CORRIGENDUM -1 TO TENDER SPECIFICATION BHEL PSSR SCT 1607 - DT:17/03/2016

Bidders are requested to download the price bid Revision 01 uploaded in the BHEL website. The price bid revision 01 is to be submitted in the offer. The revisions are listed below for ready reference.

SEPTIC TANK AND WATER TANK STRUCTURE

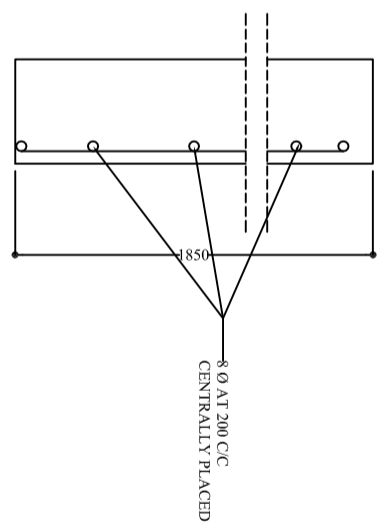
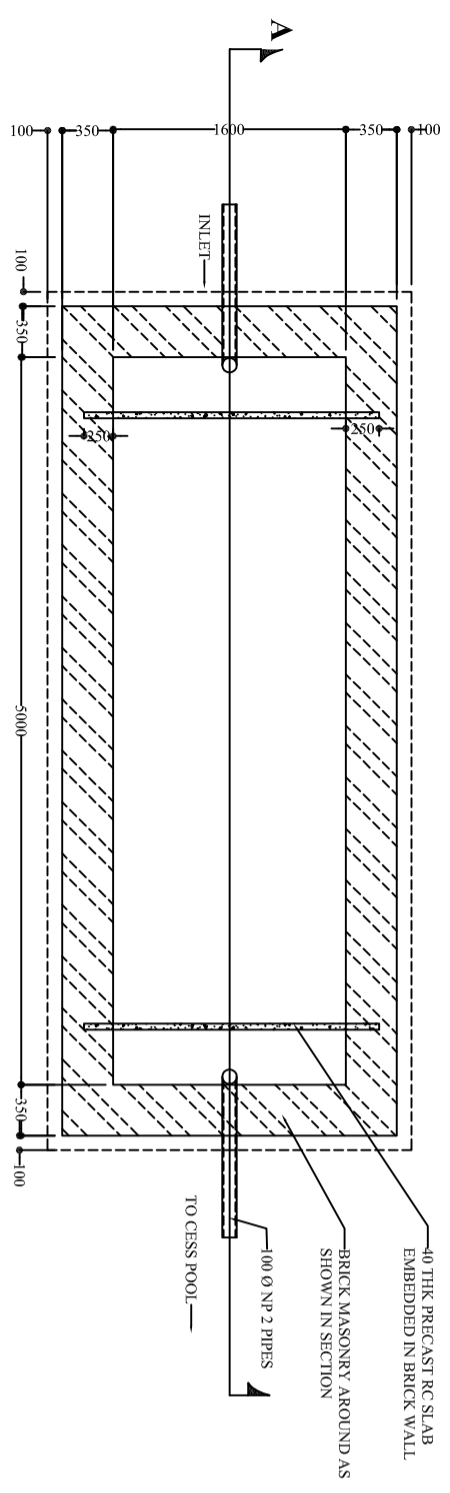
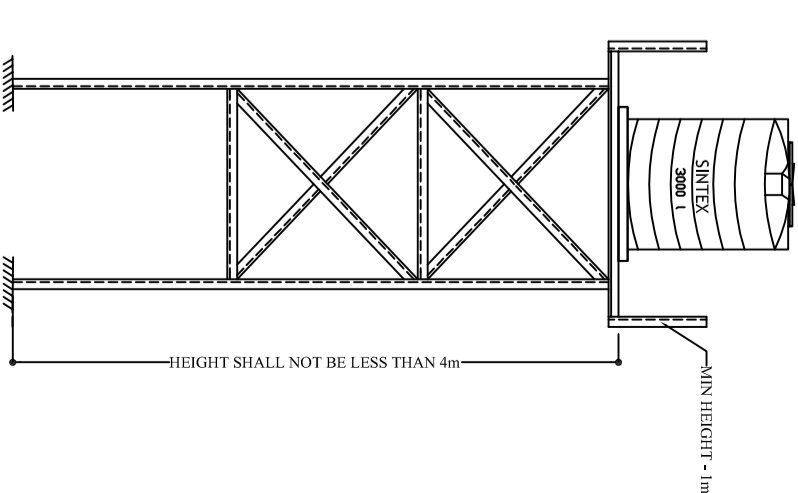
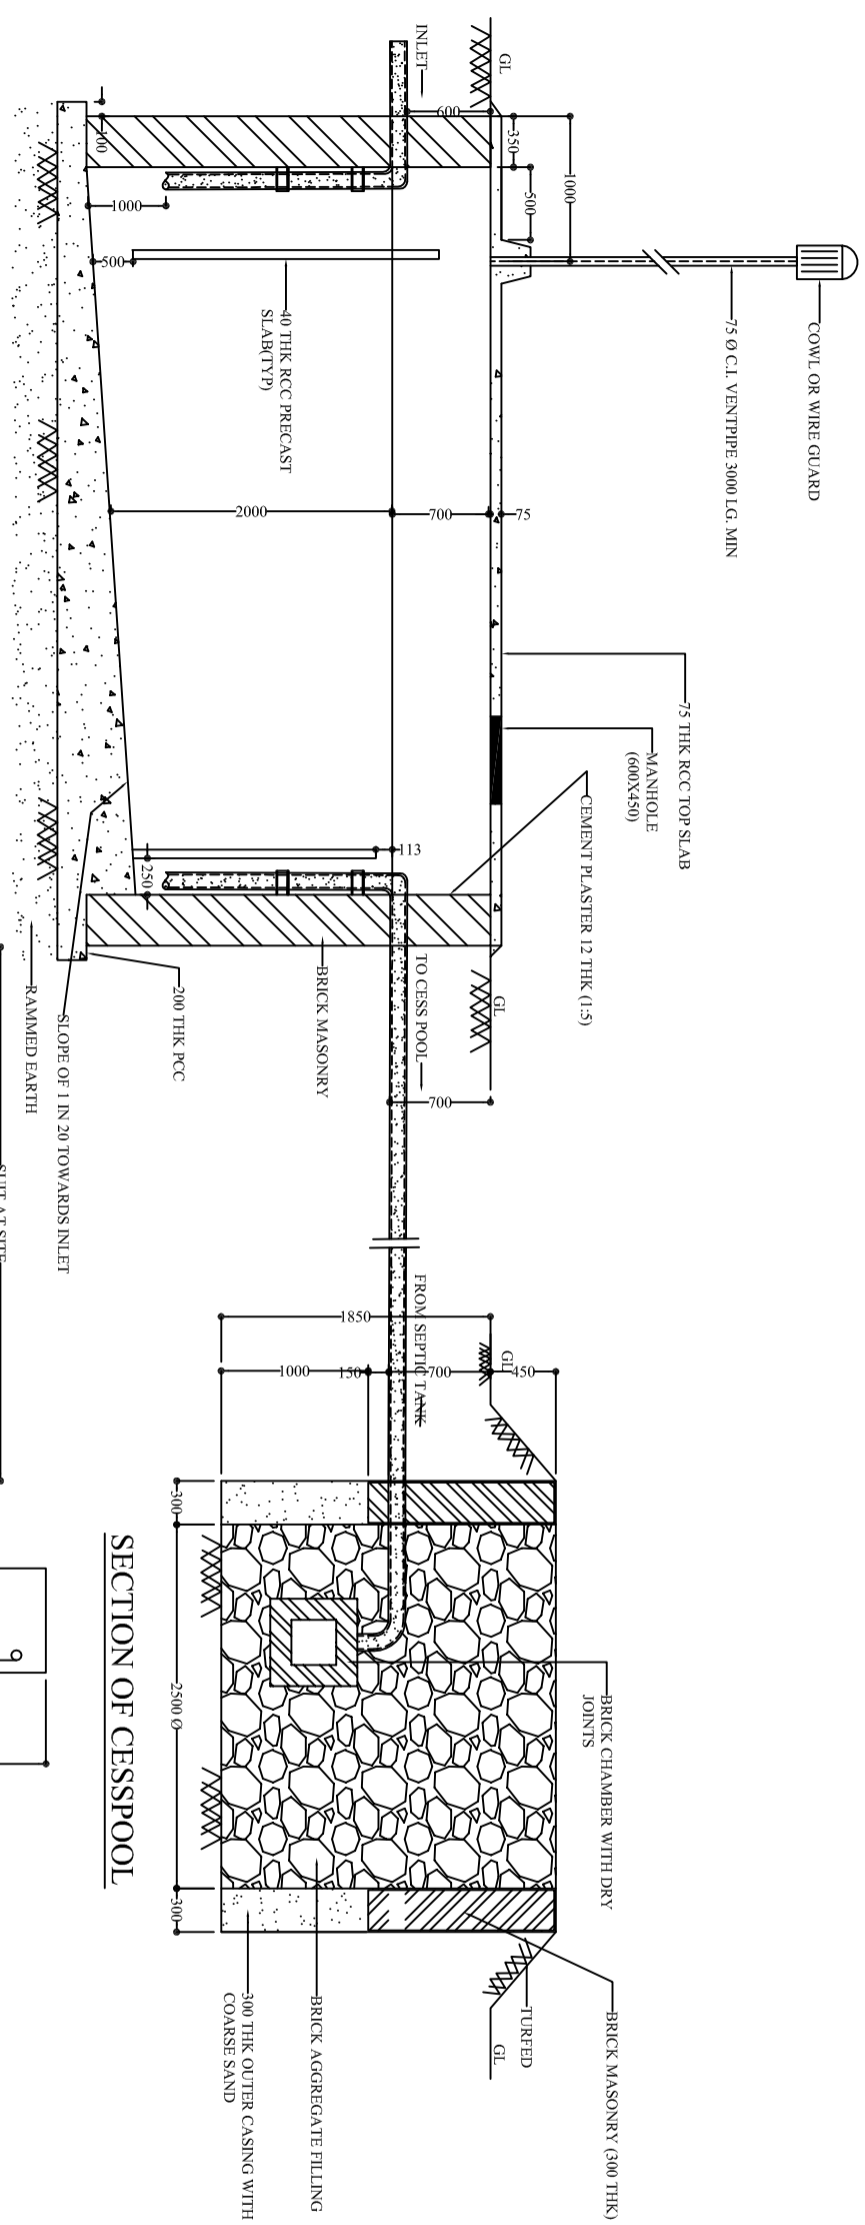
<u>Sl. No.</u>	<u>Reference</u>	<u>DESCRIPTION OF ITEM</u>	<u>Qty.</u>
1	BOQ item Ref. No. 29.0 b)	Construction of a septic tank of size 6.00 x 2.40 x 2.70 metre and a cess pool of 3.00 metre dia as per drawing no. BHE / SR / CIVIL . Rate to include cost of excavation, PCC, brick work, RCC works, reinforcement, SW pipes, AC pipes, cowl, filling with aggregates, cover slab, testing of the septic tank etc. complete all as per drawing	1

7	BOQ item Ref. No. 36.0	LED Lights may be used , as LED lights are available in markets	Bidder to quote as per BOQ
8		Wooden frames for shutters are not in the BOQ	Refer Item no. 22. Wooden frames are included. Bidder to quote as per BOQ
9		Whether the soak pit is to be covered with slab , same is not included in the BOQ	Bidder to refer enclosed drawing for "Septic Tank and Water Tank Structure" and quote accordingly.
